ADDENDUM NO. 2

February 9, 2026

Southport High School Addition & Renovation Phase 1 (Activity Center Addition & Wrestling/Center Plant Renovation)
971 E. Banta Road
Indianapolis, IN 46227

INTERIOR DETAILS

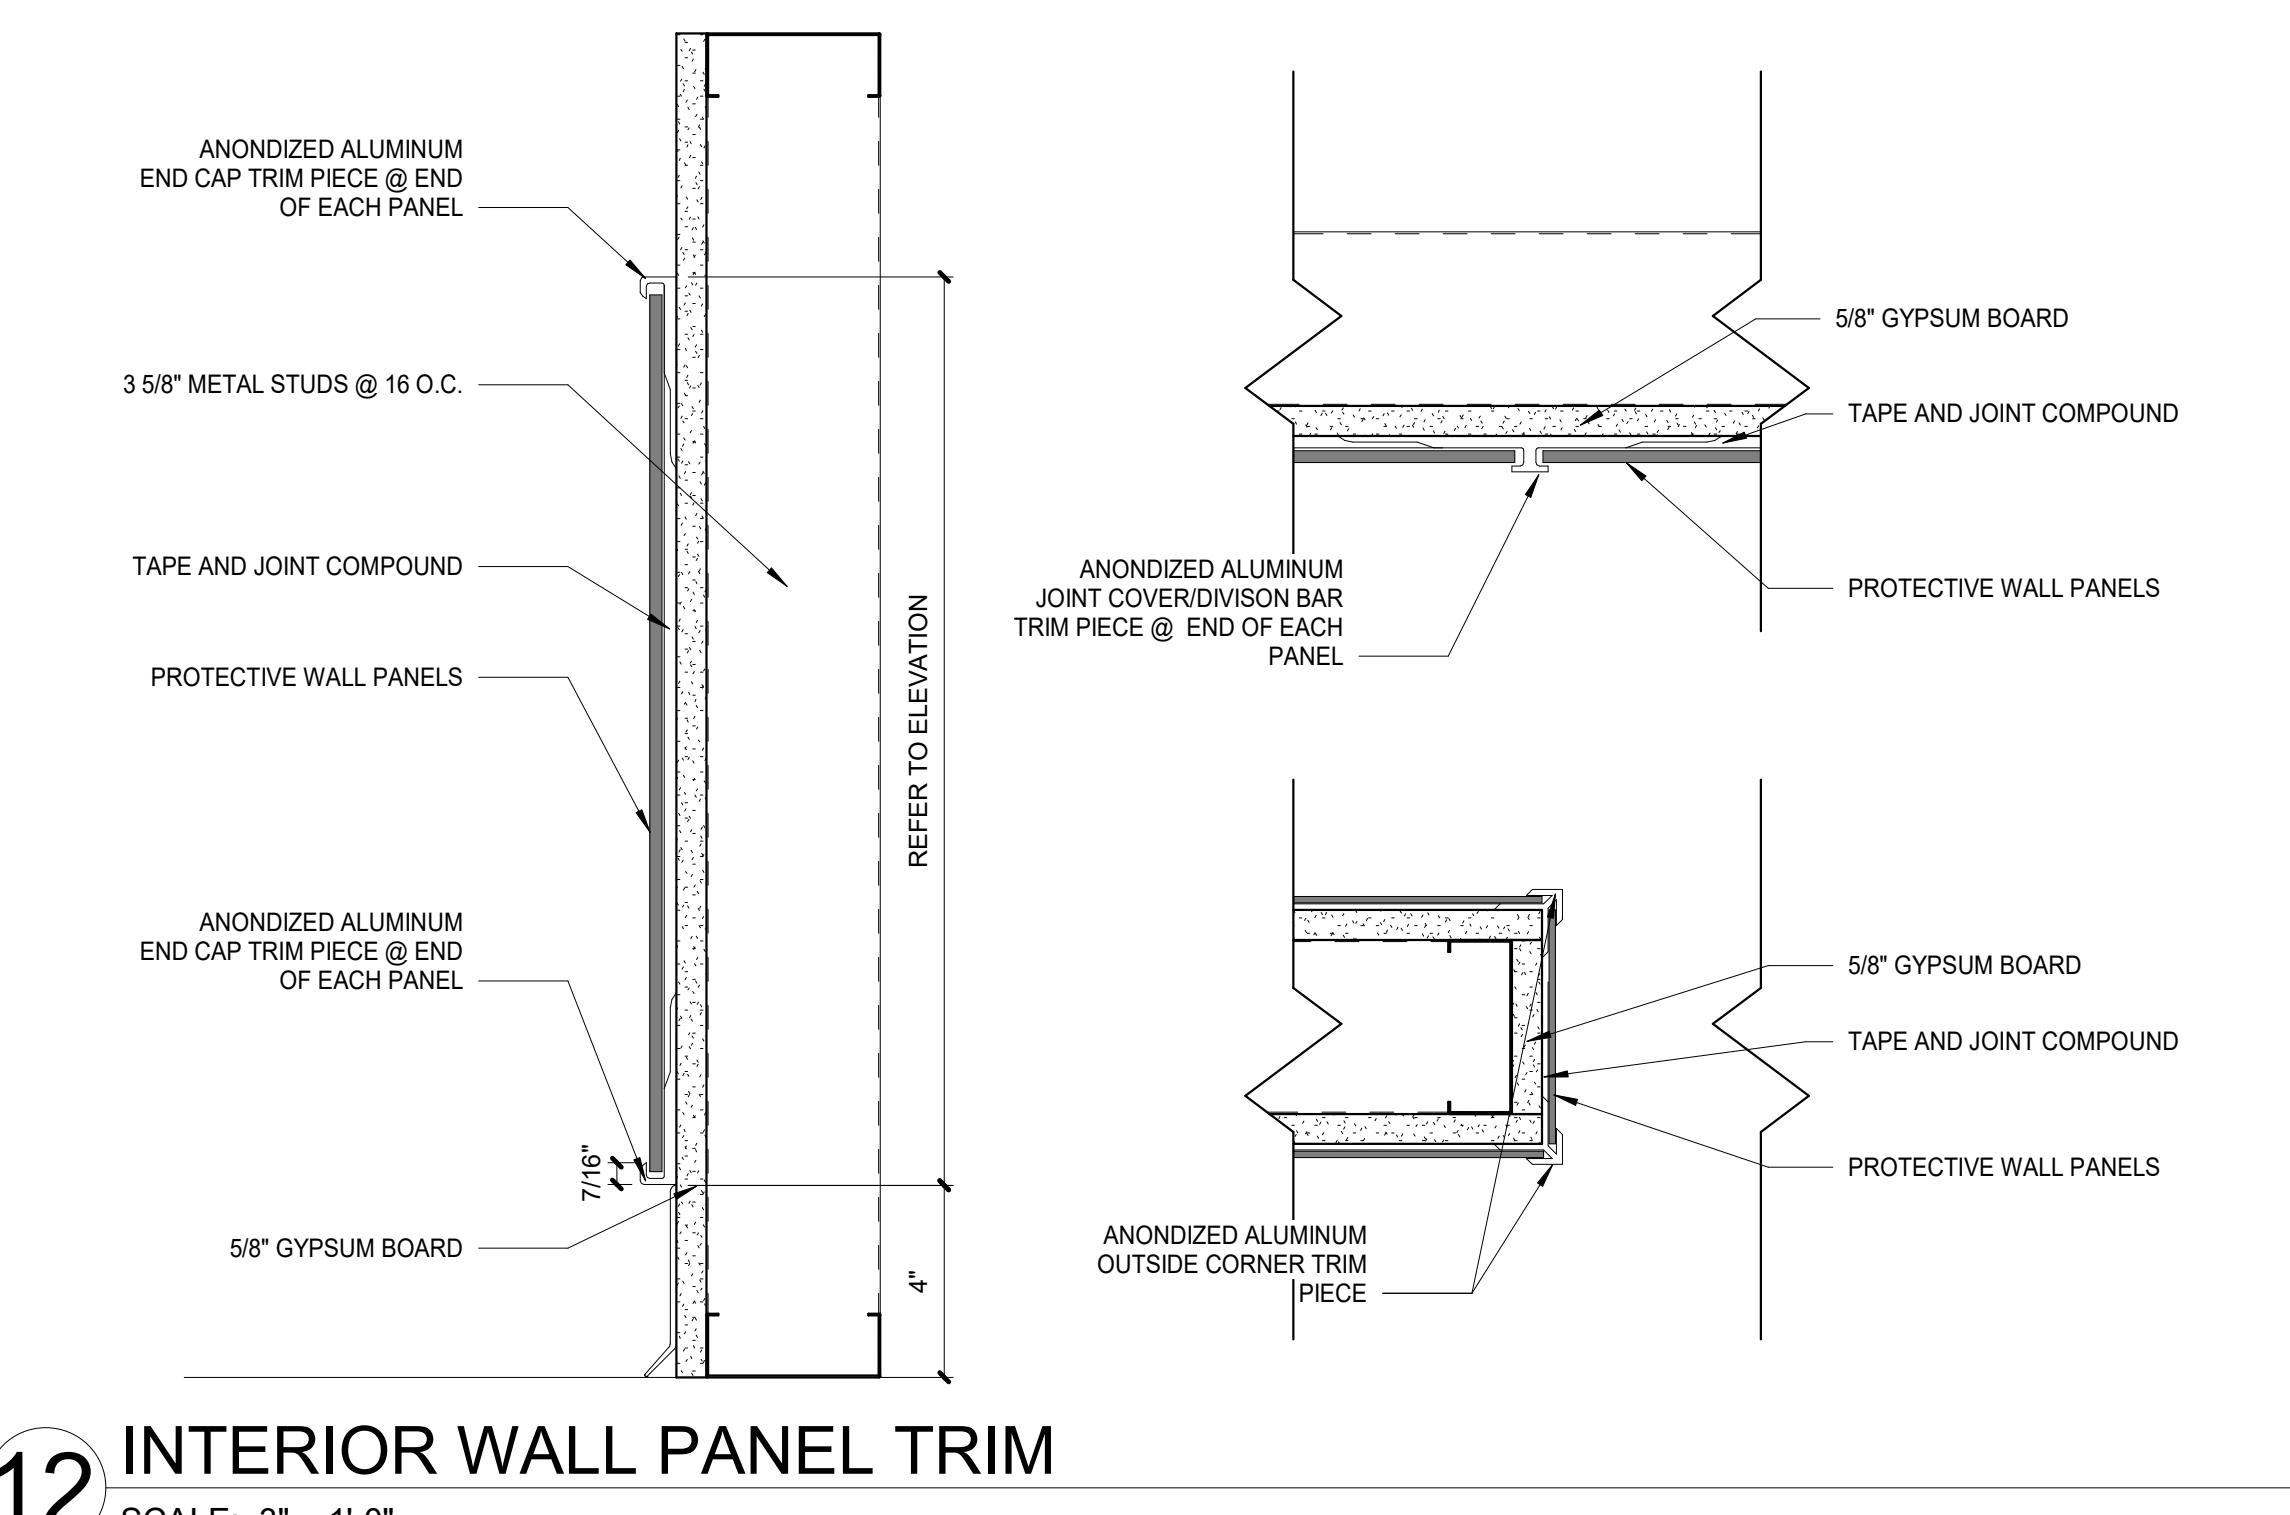
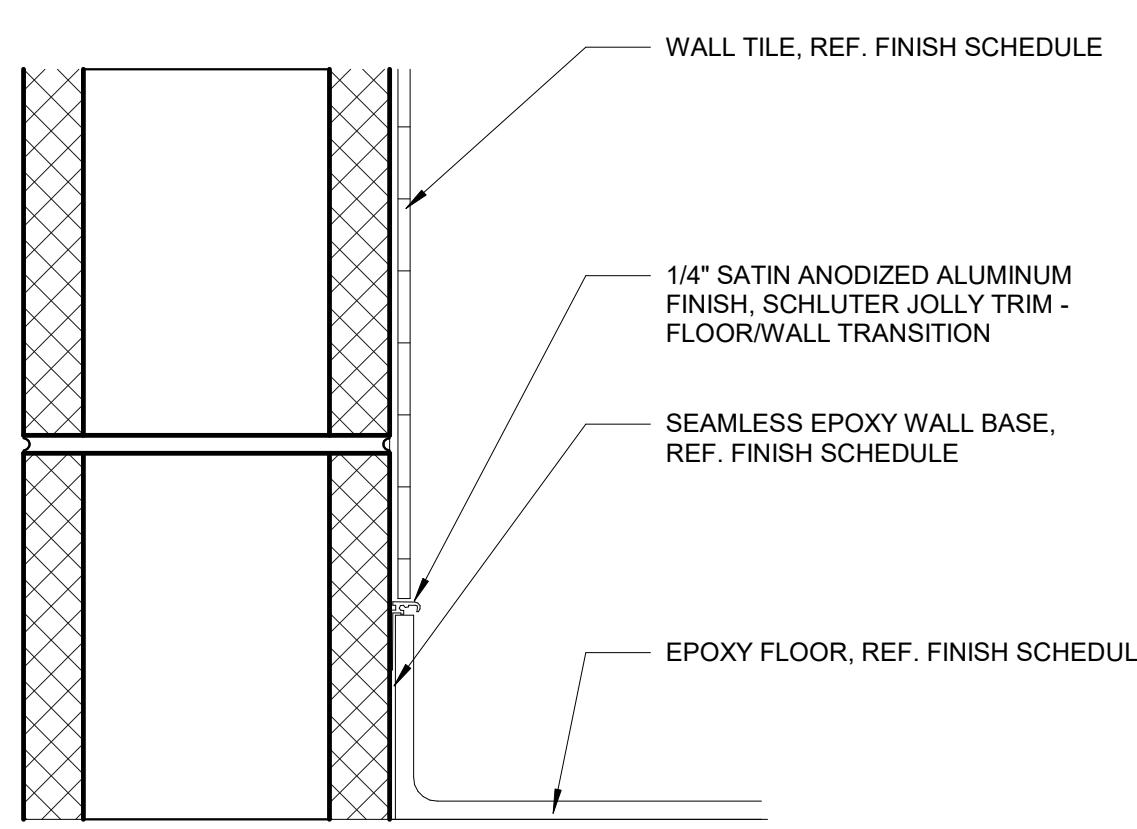
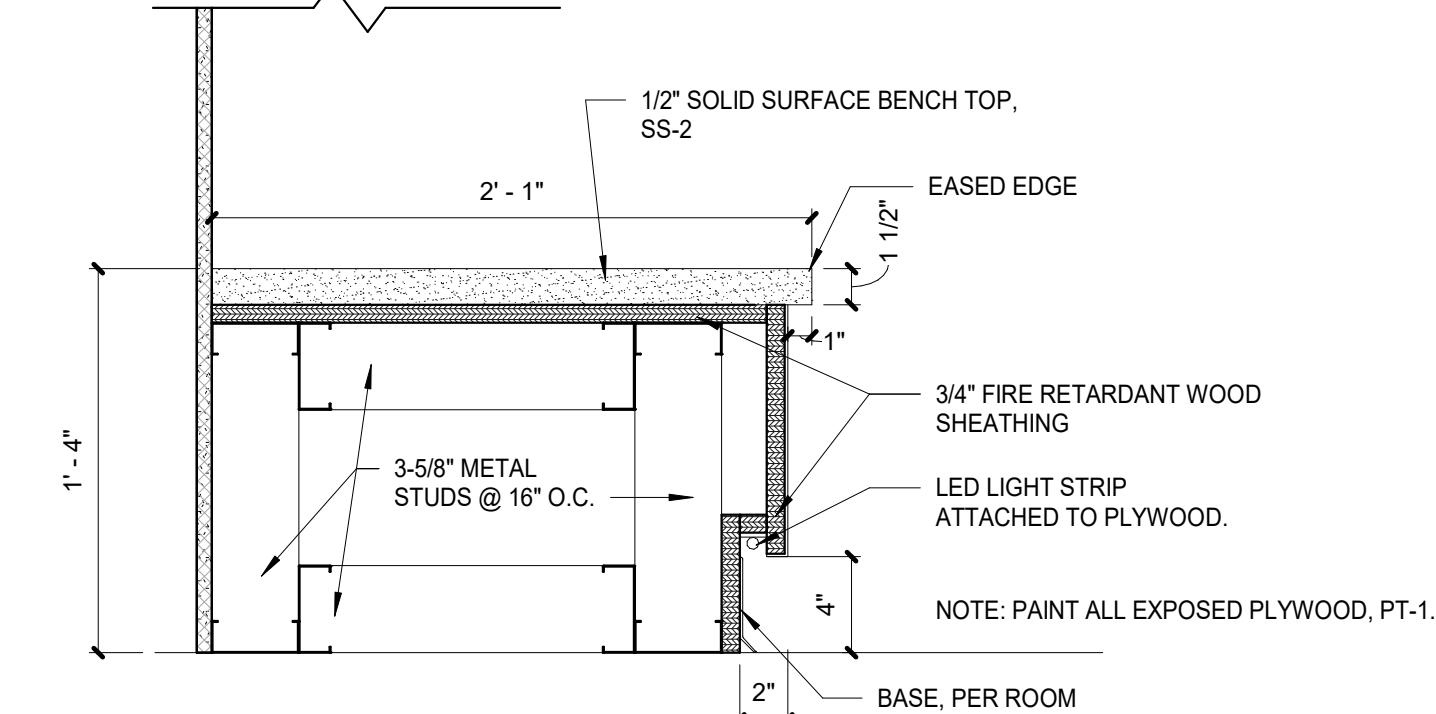
- Added section detail 10 – SECTION – FIELDHOUSE ENTRANCE WALLS

100% CONSTRUCTION DOCUMENTS
INTERIOR ELEVATIONS

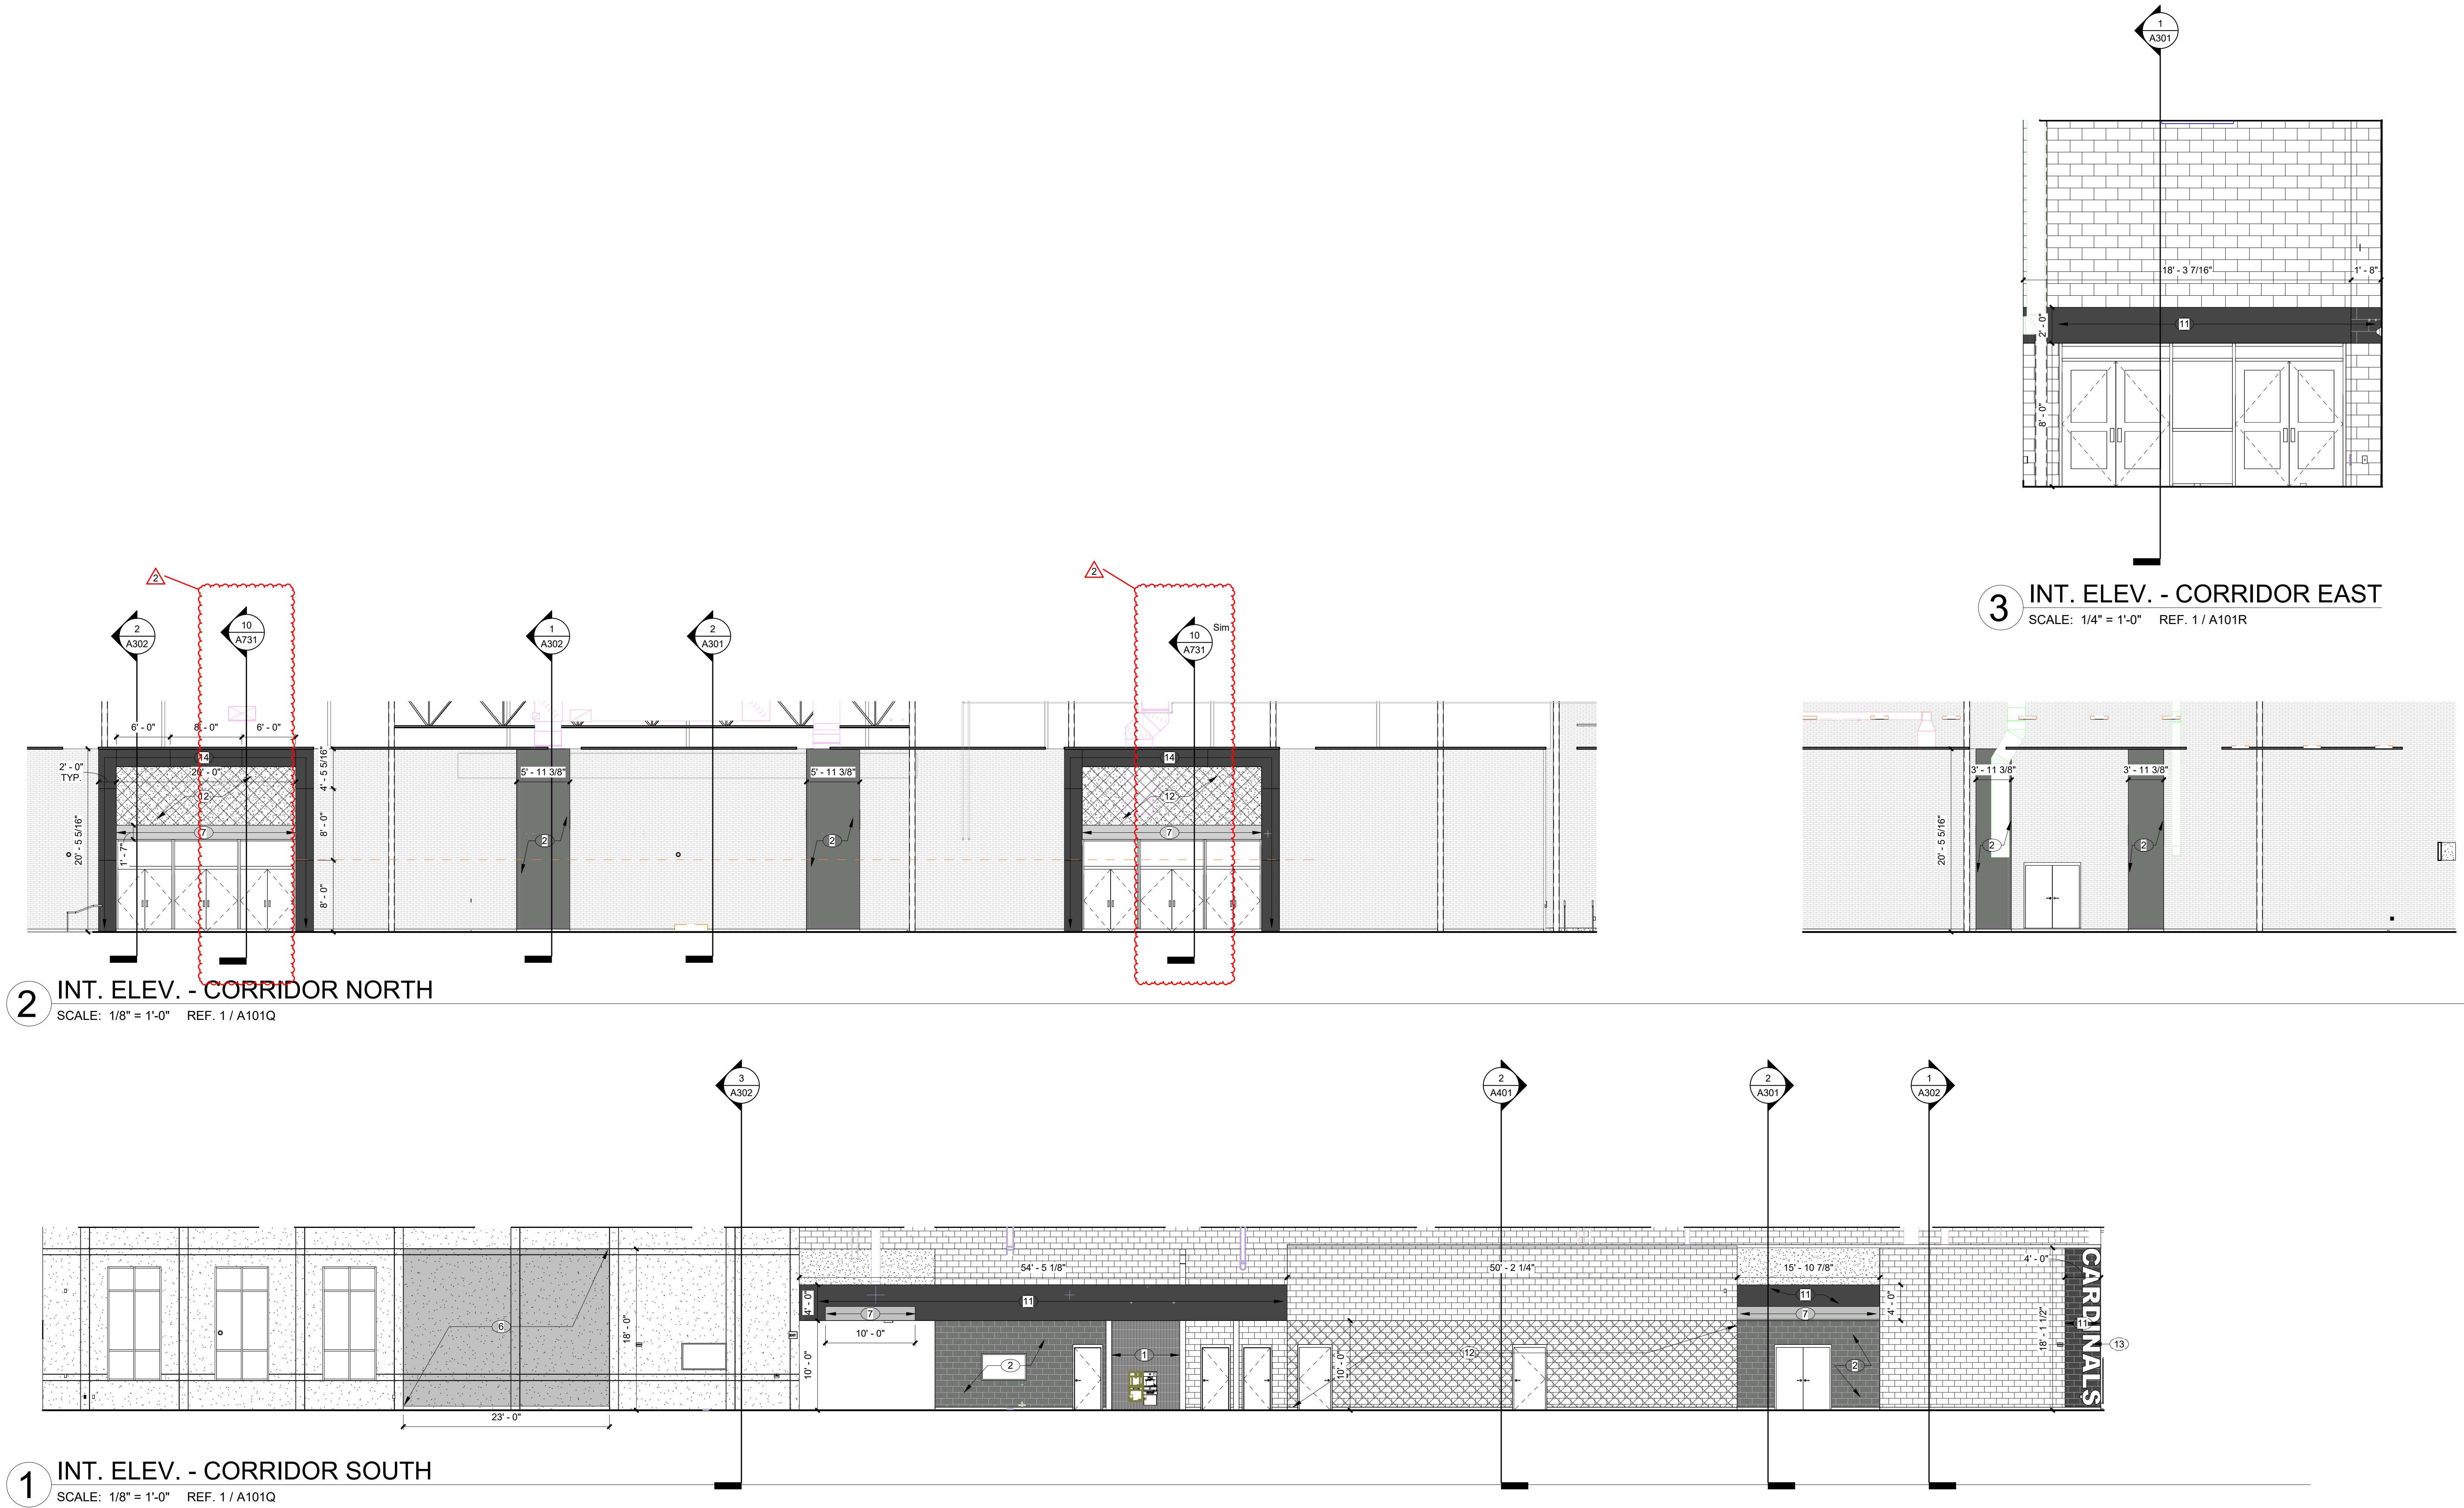
- Added section callouts for section 10/A731
